Homestake Mining Company of California

**RE: Homestake Mining Company of California – Grants Reclamation Project –
Response to NRC’s Staff Acceptance Review of the HMC Request for Amendment
to License SUA-1471 for Alternate Concentration Limits**

Attachment 1. Response to NRC comments in May 17, 2023 letter of nonacceptance of the ACL Application for technical review

Attachment 4. HMC Response to NRC Staff Talking Points from June 15, 2023 Public Meeting	
Comment	HMC Response to Comment
1-1	<p>The LAR does not provide information regarding the transfer of property and structures within the proposed control boundary including:</p> <p>The long-term disposition of infrastructure within the proposed boundary is a subject to be addressed at license termination and does not relate to the completeness of the LAR for detailed technical review. Nonetheless, HMC is providing below as much information as is reasonably practicable at this time to address the NRC staff's comments here.</p> <p>Respectfully, in HMC's opinion, none of the items in Comments 1-1 and 1-(a) through -(h) concerning property and structures within the proposed control area boundary are required by NRC regulation, or s

EXHIBIT F

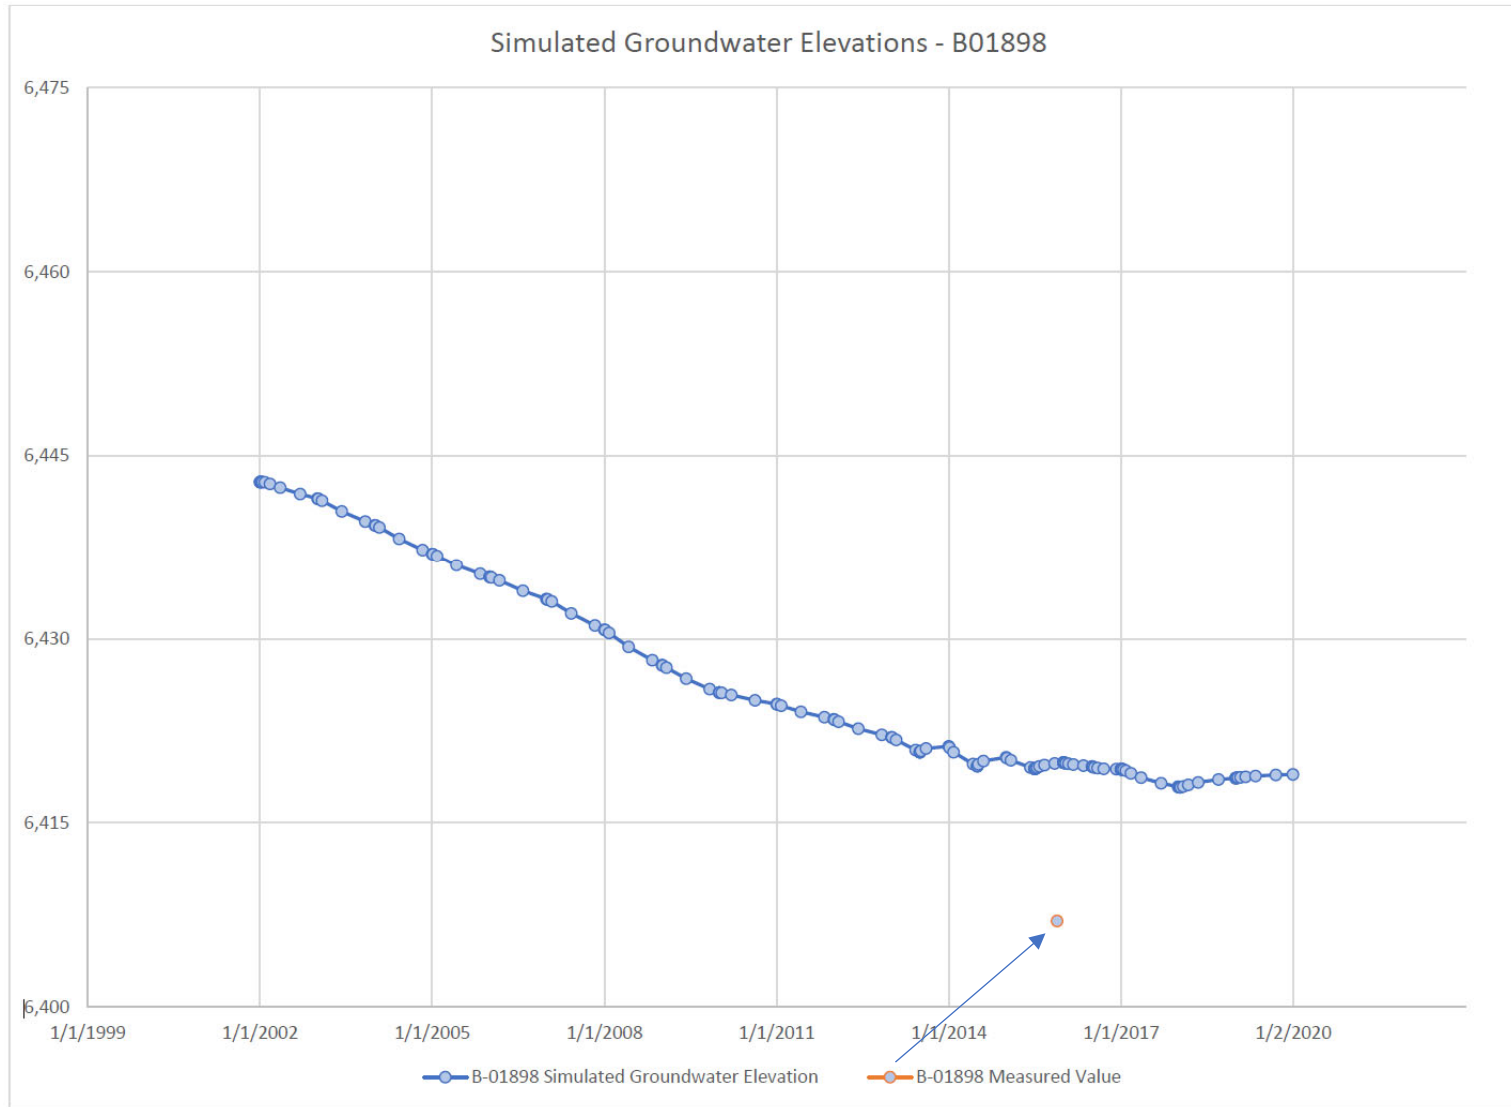
3-4	The model predicts the SAG aquifer is dry in the area west of Route 122 that appears to be contrary to the conceptual model of recharge to the SAG along the northwestern flanks of the Zuni Mountain.	This comment reflects detailed technical review issues and should be addressed during that process. It does not provide a sufficient basis in regulation or guidance for declining to accept the application for detailed technical review.
3-4 Discussion	<p>The model predicts the SAG aquifer is dry in the area west of Route 122. This prediction is based on a thickness of the SAG of 350 feet and may or may not be correct. The prediction, however, is contrary to the conceptual model of recharge to the SAG along the northwestern flanks of the Zuni Mountain (see Figures 23 and 24 in the Licensee's San Mateo Creek Basin and HMC Hydrogeologic Site Conceptual Model).</p> <p>It is possible that lowering of the SAG potentiometric surface by 40 feet during the previous 30 years may have resulted in drying of the recharge area. However, the New Mexico State Engineer database lists a well (B-01898) completed in 2015 near the location of the southwestern boundary of the modeled area. The well has a depth to water of 300 feet and a depth of 400 feet, which the driller described as limestone and sandstone. The surface elevation at this location is estimated by staff at 7000 ft-MSL. This information can be interpreted that the Glorieta is partially saturated though the potentiometric head is significantly higher than that measured in the Rio San Jose valley.</p>	<p>Estimating ground surface elevation at well B-01898 from Google Earth yields an approximate value of 6,707 feet. Subtracting 300 feet from ground surface, yields an approximate groundwater elevation in this well of 6,407 feet. The screen shot provided in Exhibit F for the end of the historical calibration period shows the well location and the simulated dry cells in purple and, where the aquifer is saturated is colored white. The well is simulated as being saturated by the model.</p> <p>The simulated heads versus the observed value provided in Exhibit F shows the model slightly overestimates groundwater elevations close to the mountain front contrary to NRC's assertion. Therefore, the model is not in conflict with the conceptual model of recharge along the Zuni Mountains.</p>
